Town of Breckenridge
Planning Commission Agenda

Tuesday, August 3, 2010
Breckenridge Council Chambers
150 Ski Hill Road

Planning Commission Staff Report

Planning Commission Staff Report

COLORED SITE PLAN
 All to

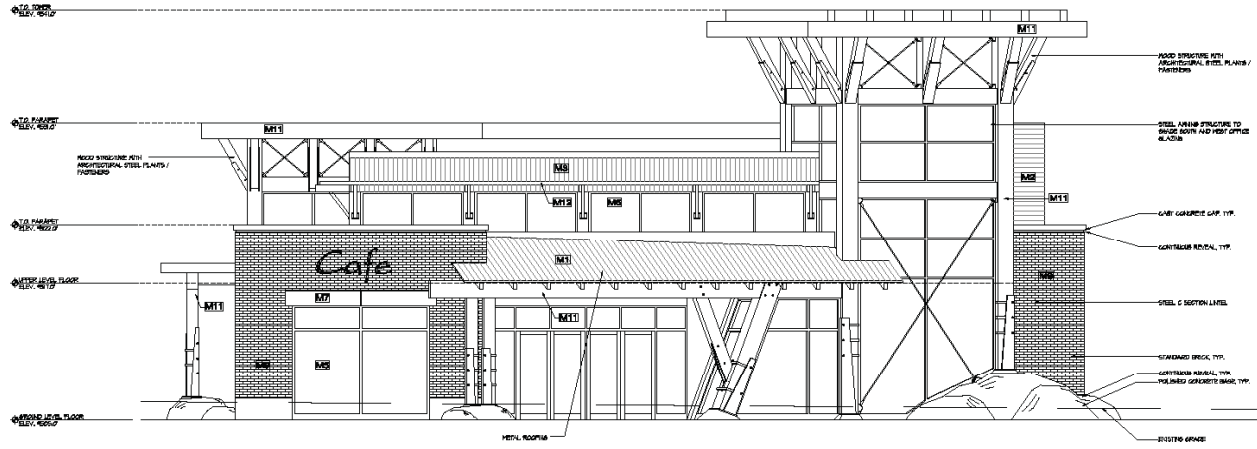
Site and Environmental Design (7/R): The proposed site plan for the project allows for the building to have frontage on both Park Avenue and Airport Road. Parking will be screened from view by the building itself on Airport Road and through a landscaping buffer along Park Avenue. The site is accessible from both Park Avenue and Airport Road by a common driveway. Staff is supportive of the site plan and believes it follows the anticipated buildout plan of the 2004 subdivision. Construction of the driveway, common parking lot, landscaping of the common driveway and the public improvements was approved during the 2004 resubdivision. The applicants have stated they plan begin work on these improvements before breaking ground on the proposed building. Below is language from the findings and conditions from the 2004 resubdivision.

Snow Removal And Storage (13/R): The proposed snow-stacking meets the required threshold of twenty five percent (25%) of the areas to be cleared of snow. Staff is comfortable with the proposed snow stacking plan.

Access: The proposed access remains unchanged from the plan approved by the Planning Commission during the 2004 subdivision. The access point on Airport Road is proposed as a 3/4 movement, "right-in, right-out" and "left-out". The other proposed access point is from Park Avenue, is also proposed as a 3/4 movement, with "right-in, right-out and left-in" accesses, due to the existing and anticipated volume of traffic on North Park Avenue. These movements were acceptable to the Town Engineer and the Colorado Department of Transportation.

The proposed plan shows traffic islands at the entrances to this site to guide vehicles toward the permitted turning movements. One traffic island is on the applicant's property, and the other is in the Park Avenue right-of-way. Per plat note 13 of the subdivision, in lieu of constructing a traffic island on Airport Road the applicant may pay the Town an amount equal to the estimated cost of the island which may be used by the Town when such improvements are necessary.

Landscaping (22/A & 22/R): The applicants are proposing to add 33 aspen trees (7-1" caliper, 11- 1.5" caliper, and 15- 2" caliper) and 26 Colorado spruce trees (4 – 8', 6 – 10', 8 – 12' and 8 -14'). A significant number of these planting (21) are proposed adjacent to Park Avenue and Airport Road. Staff would like feedback from the Commission on the landscaping plan.
